**MEMORANDUM**

Re: Response to County Comments on  
Water Availability Analysis  
Pritchard Hill Properties LLC  
APN Nos. 032-560-023 and 031-010-034

Job No. 643-NPA05

**FIGURE 1A  
WATERSHED  
GEOLOGY**

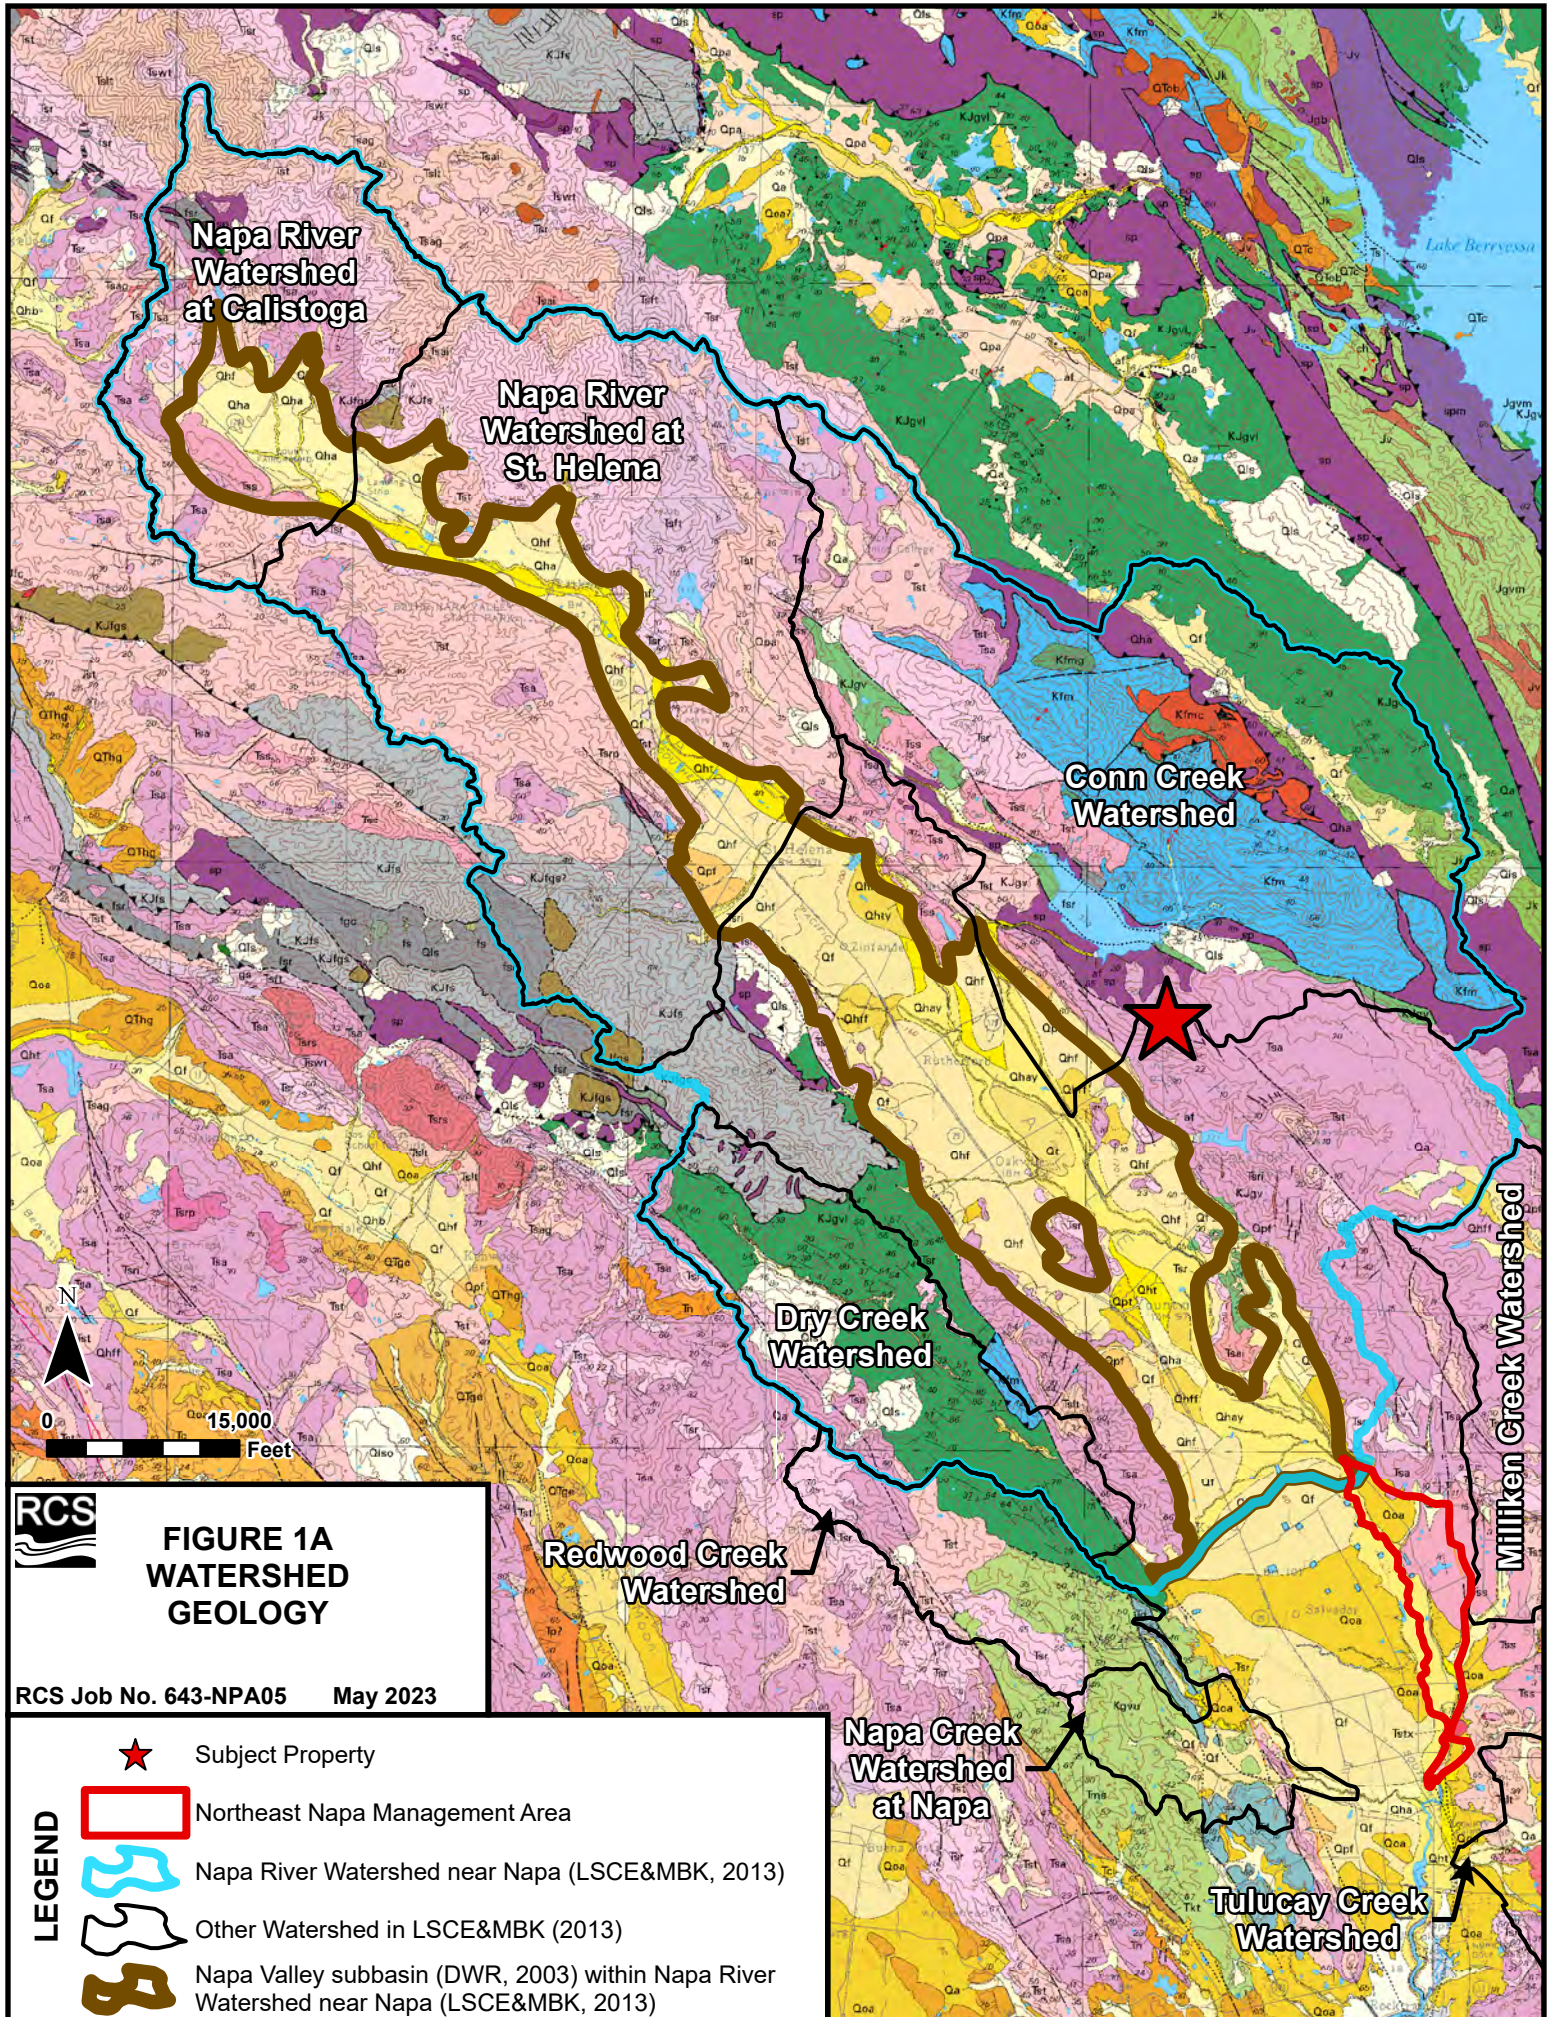
**Provide more information on how the 14% recharge rate was determined, and how this property relates to the Conn Creek watershed and Napa River near Napa watershed recharge rates from the LSCE & MBK 2013 Memorandum.**

The stated 14% recharge value was derived by RCS for those prior, nearby projects as follows. Prior to the publication of LSCE & MBK (2013), recharge estimates regularly used by RCS and others for the Sonoma Volcanics throughout Napa County in different watersheds have historically ranged from 7% to perhaps 14%. A more site-specific estimate of the deep percolation rate of rainfall at the subject property can be made using data from LSCE & MBK (2013) in conjunction with the county-provided 10-year average PRISM rainfall dataset (Napa County, 2022) and the boundary of the Napa Valley subbasin of the Napa-Sonoma Valley Groundwater Basin (adapted from CA DWR, 2003). Figure 1A shows the watershed boundaries of LSCE & MBK (2013), superimposed on a geologic map of the region (USGS, 2007); Figure 1B shows a reproduction of the explanation of geologic units and symbols for that USGS map. The bold brown line shown on Figure 1A represents the approximate outline of the Napa Valley subbasin (CA DWR, 2003), which

roughly delineates the boundary between alluvial deposits on the Napa Valley floor (shown as tan to light yellow areas) and the hill and mountain areas that generally surround these alluvial deposits. The subject property is shown on Figure 1A lying just east-southeast of the boundary of the Napa River Watershed Near Napa, and in the same Sonoma Volcanics rocks that comprise a large portion of the western side of the watershed.

As discussed above, LSCE & MBK (2013) estimated that 17% of the average annual rain that falls within the “Napa River Watershed near Napa” undergoes deep percolation and recharges the groundwater in the local aquifers. However, this “recharge rate” estimate is a watershed-wide water balance-based average that does not differentiate between hydrogeologically distinct areas of the watershed. It is more likely that the actual percentage of rainfall that undergoes deep percolation into the valley floor alluvial deposits (within the brown boundary on Figure 1A) of the “Napa River Watershed near Napa” is significantly higher than the percentage of rainfall that undergoes deep percolation into the geologic materials that are exposed throughout the hillside and mountain areas of the watershed.

A more hydrogeologically plausible estimate of the groundwater recharge rate in the hill and mountain areas can be calculated by assuming that this rate is higher within the Napa Valley subbasin portion of the watershed (primarily valley floor alluvial deposits), relative to the groundwater recharge rate in the hill and mountain areas of the watershed that are outside of the subbasin (and are generally underlain by different geologic materials that are more consolidated and generally less permeable). This is as opposed to using a constant groundwater recharge rate throughout the entire watershed, as presented by LSCE & MBK (2013). The key value that is required to calculate this estimate is the average volume of rain that falls in each of these distinct portions of the watershed (valley floor areas versus hill and mountain areas). To accomplish this, the following values (also presented on Table 1, “Calculation of Theoretical Rainfall Recharge Percentage - Napa River Near Napa Watershed”) were calculated with a GIS:

Based on the analyses presented in Table 1, a value of 14% is an appropriate and conservative estimate for the groundwater recharge rate for areas within and proximal to the “Napa River Watershed Near Napa”, but outside of the alluvial deposits of the Napa Valley subbasin (e.g., the subject property).
